Product Change Announcement
August 2015

- **Affected Product: Face Screws for Steel Studs**
- **Effective Date: Ship-out date of 8/1/2015 or later**

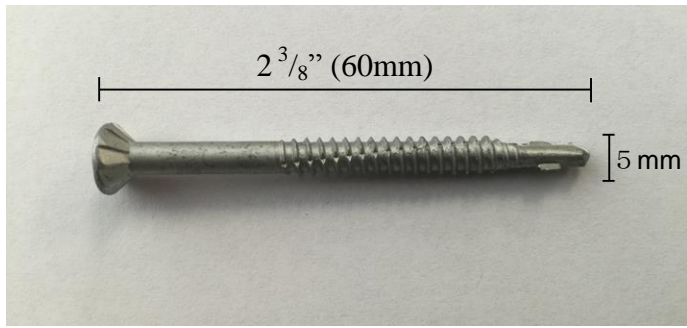
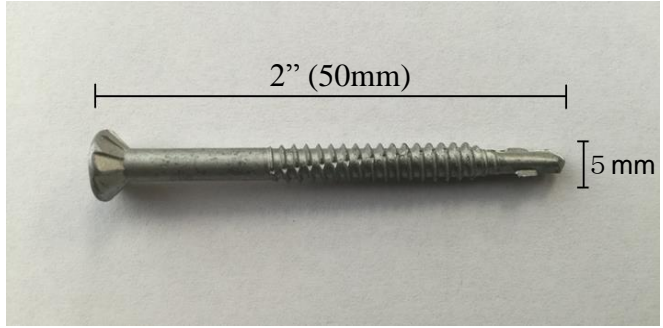
<Discontinued Product: RY8820A> Face Screws for Steel Studs

<New Product: B88501> Face Screws for Steel Studs

The new screws have the same head diameter but a shorter length

Discontinued Product	New Product
RY8820A	B88501
 <p>2 ³/₈" (60mm)</p> <p>5 mm</p>	 <p>2" (50mm)</p> <p>5 mm</p>
